TOWN OF LOS GATOS  
PLANNING DIVISION

Re: Arborist Addendum for Proposed Driveway at 16 Chestnut Ave. in Los Gatos

**Figure 1: driveway configuration option #1, retaining approximate original footprint**

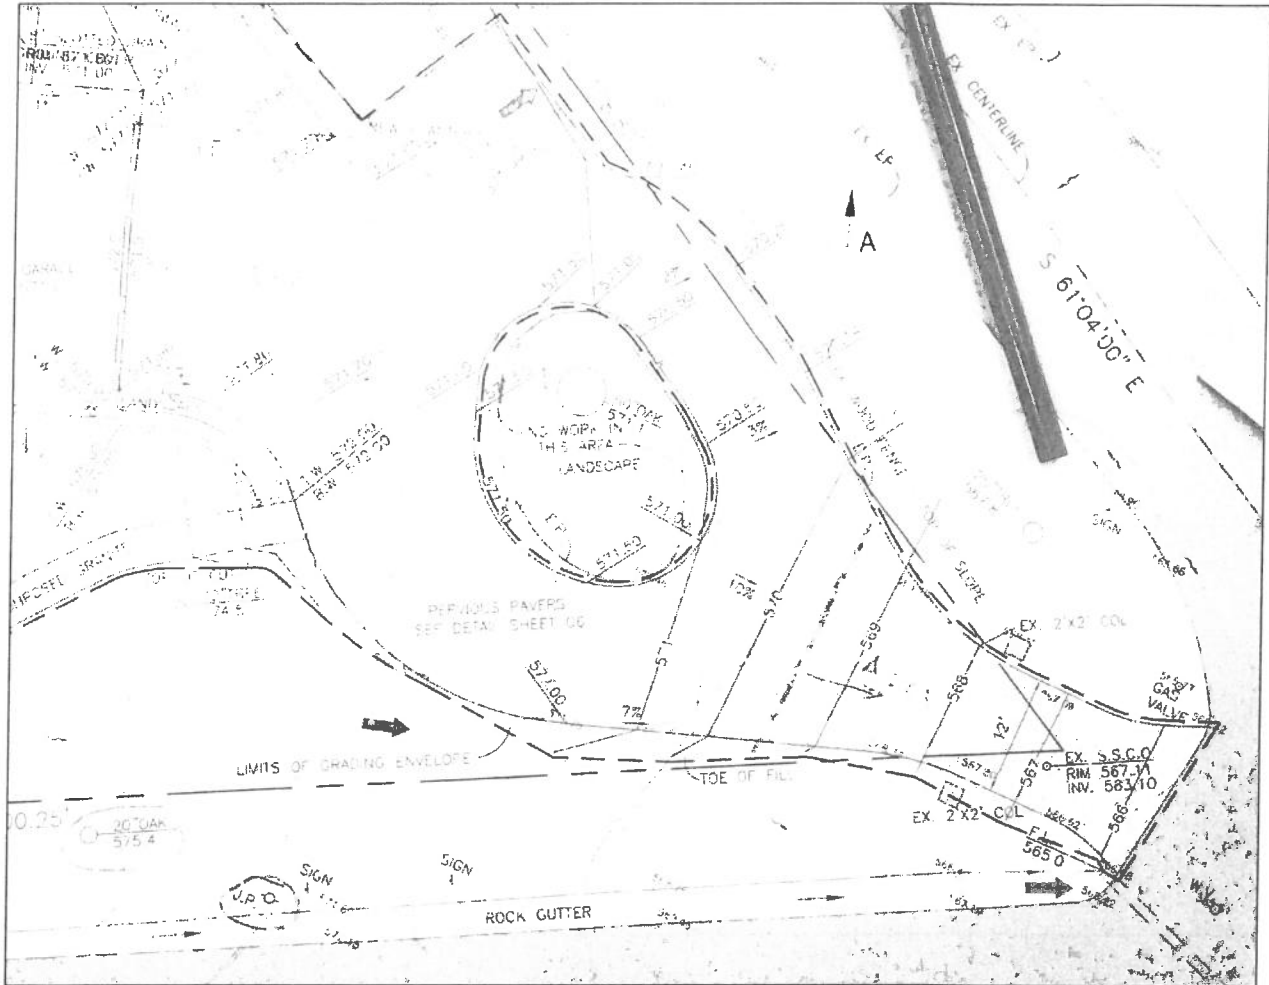
#### ***Footprint option 1: similar to existing (Figure 1)***

The driveway footprint recommended by the construction team is largely the same as the existing footprint. The bare dirt area around the trunk would be expanded slightly. No grading would be needed immediately around the tree, and the existing sub base for the existing asphalt would remain in place, to be re-compacted and used for the new driveway material. A small amount of fill and additional sub base would be necessary in portions of the driveway between the tree and the street.

1. If feasible, implement option 1B for driveway installation: retain approximately the existing footprint, and use crushed rock for the new driving surface. Option 1A is also acceptable: retain approximately the existing footprint, and use pervious pavers for the new driving surface.

**Figure 2.1: driveway configuration option 2 (first version)**

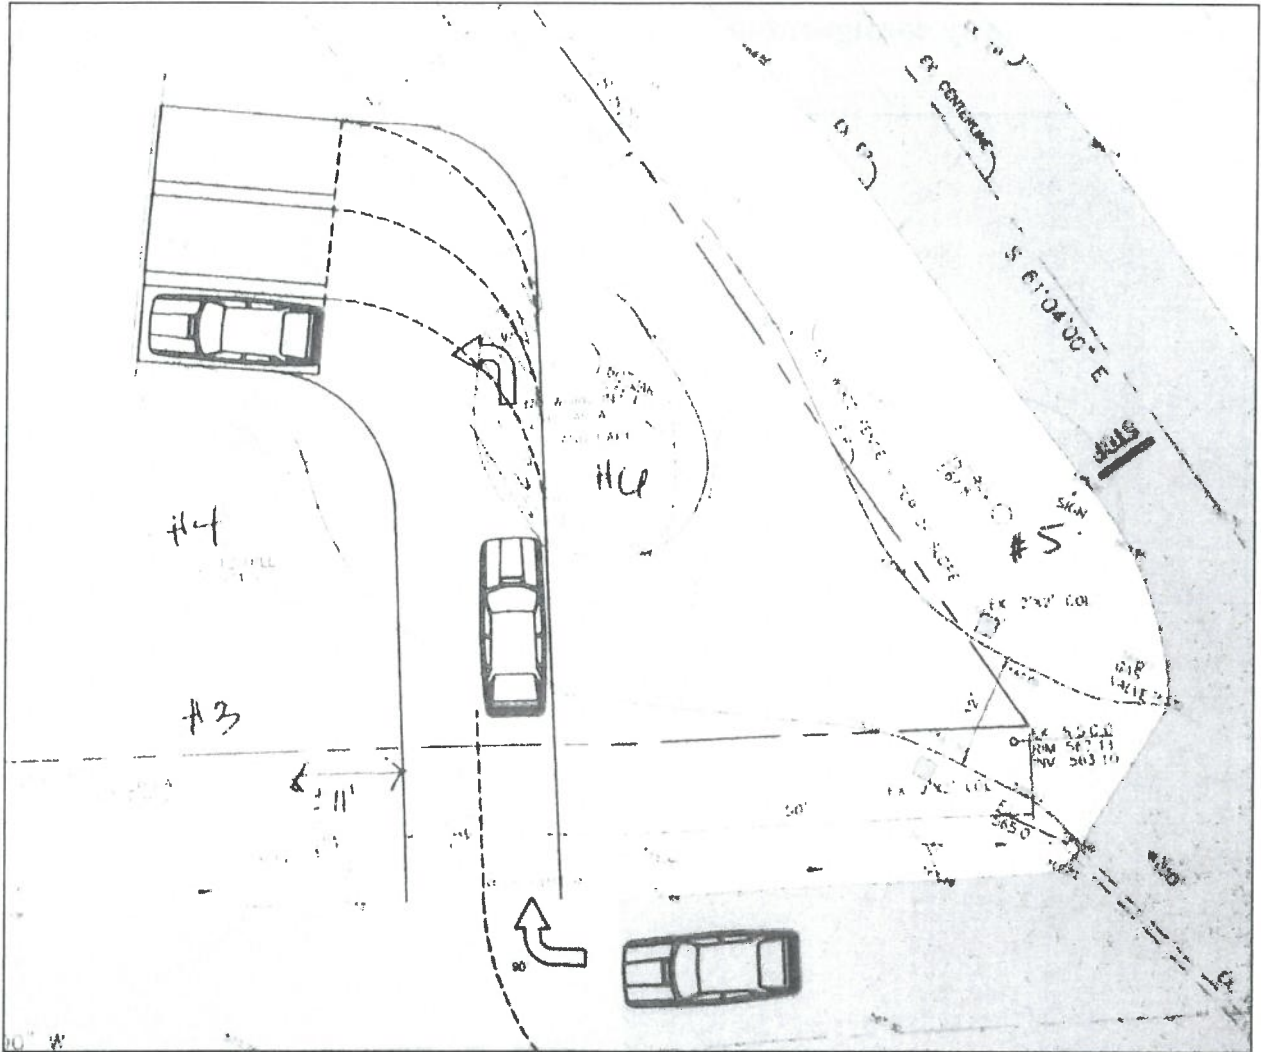
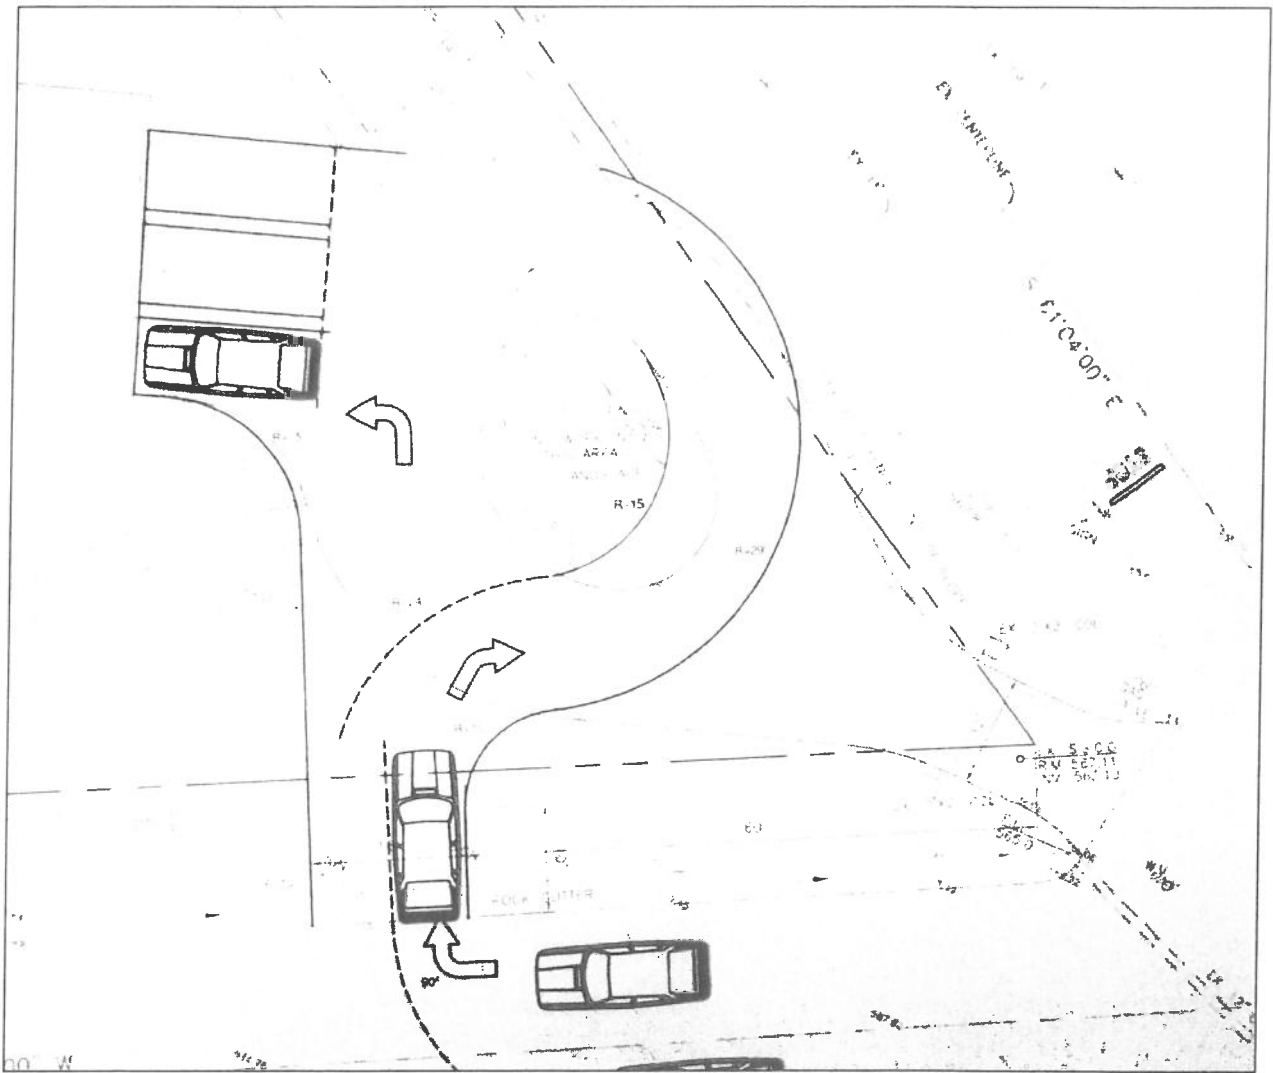
#### ***Footprint option 2: entry from Chestnut Ave. (Figures 2.1 and 2.2)***

Reconfiguring the driveway to enter from Chestnut Avenue would require substantial grading in all areas. It would also require bringing the edge of pavement closer to tree #6, resulting in substantial root loss. Two versions of this option exist, both with the same issues.

The project engineer does not recommend this option, as it may create conflict between the driveway and underground utilities.

2. If driveway options 2 or 3 are used (entry from Chestnut Ave. or Hernandez Ave., respectively), remove tree #6 prior to making grading cuts.

**Image 1: tree #6 (from my original arborist report)**

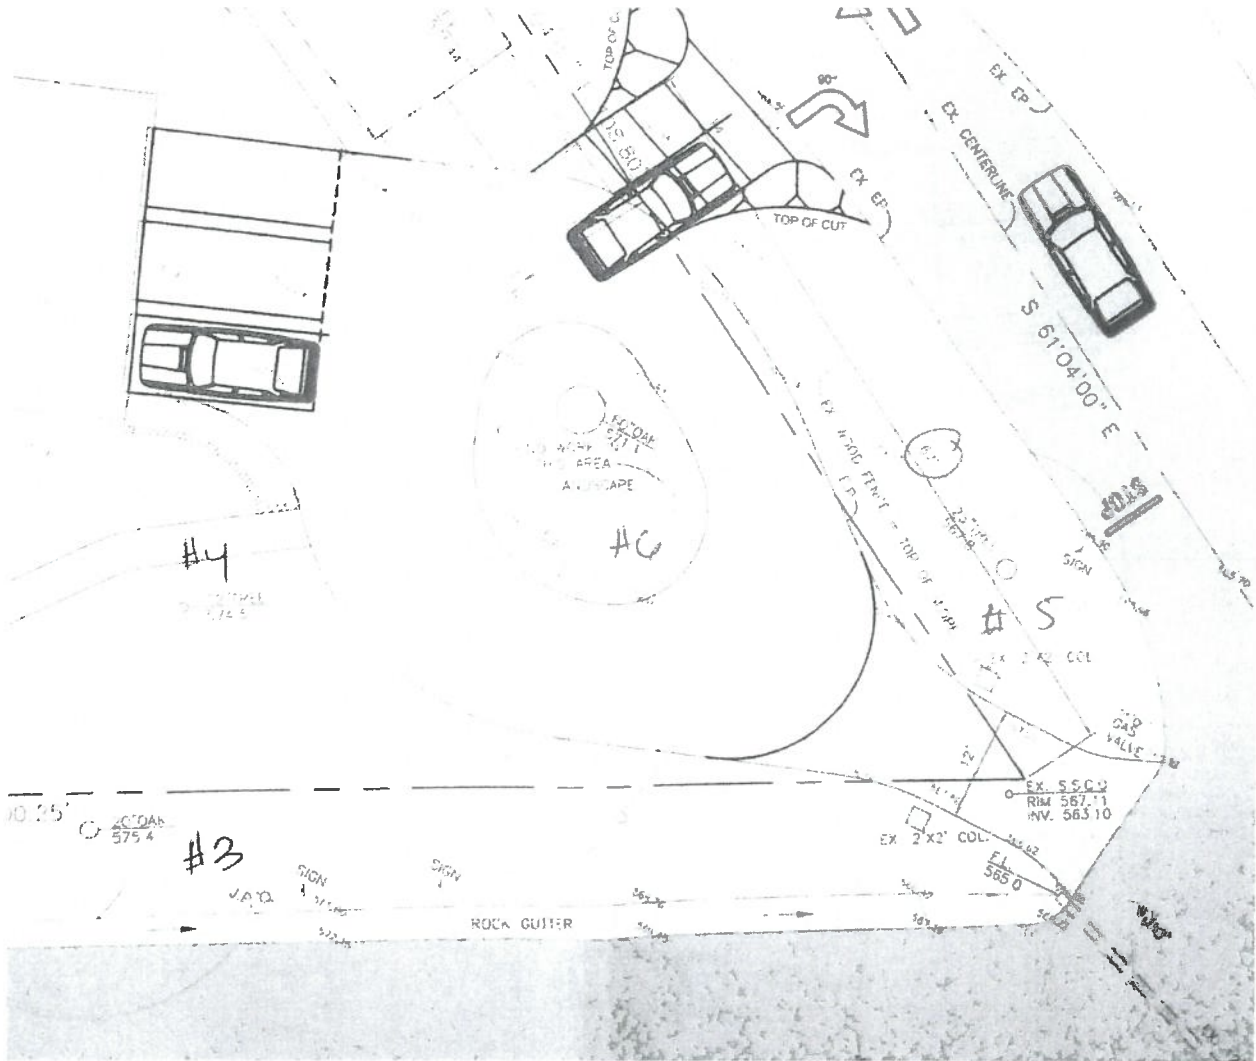
***Tree health and critical root zone (Image 1)***

Tree #6 is in poor condition. It appears over mature, with low vigor. Its critical root zone encompasses nearly the entire driveway area, and a substantial distance beyond. For a more detailed analysis of this tree's condition, please see the Tree Protection Report for this project.

Thin canopy  
for species

Decay cavity  
with little  
reaction growth

Girdling  
roots

- a. Follow all care and protection measures recommended for tree #6 in the Tree Protection Report for this project.
  - b. After construction is complete, perform root zone remediation in all unpaved areas within the CRZ of tree #6, as recommended in the Tree Protection Report:

1. Decompact the soil with an air spade,
    2. Incorporate compost into the soil with the air spade, and
    3. Spread wood chips over the top of the decompacted soil to a depth of 3-6 inches.
